Historic Architectural Review Commission Staff Report for Item 4

Application Number: C2025-0025

Address: 525 Southard Street

Description of Work:

Photo of site under review with temporary generator to be removed.

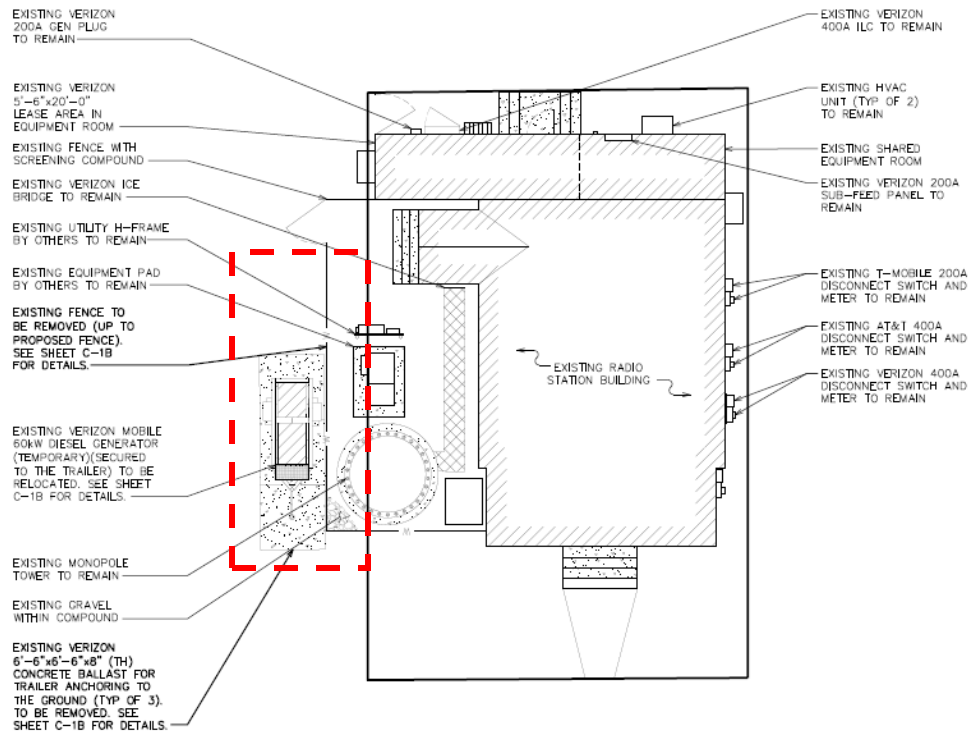
The Certificate of Appropriateness proposes the demolition of the existing concrete pad, partial removal of the fence structure and pergola, and the removal of the temporary generator. About 19 feet of existing wooden picket fencing and pergola structure, originally installed in 2004 as part of a 33.25-foot span, will be removed. This removal is necessary to accommodate the placement of the new generator within the existing tower compound. The new fencing will be installed 8 feet 6 inches outward from the current fence line and then returned back in order to enclose the generator. The new fencing will match the existing material and style to ensure visual consistency with the surrounding site elements.
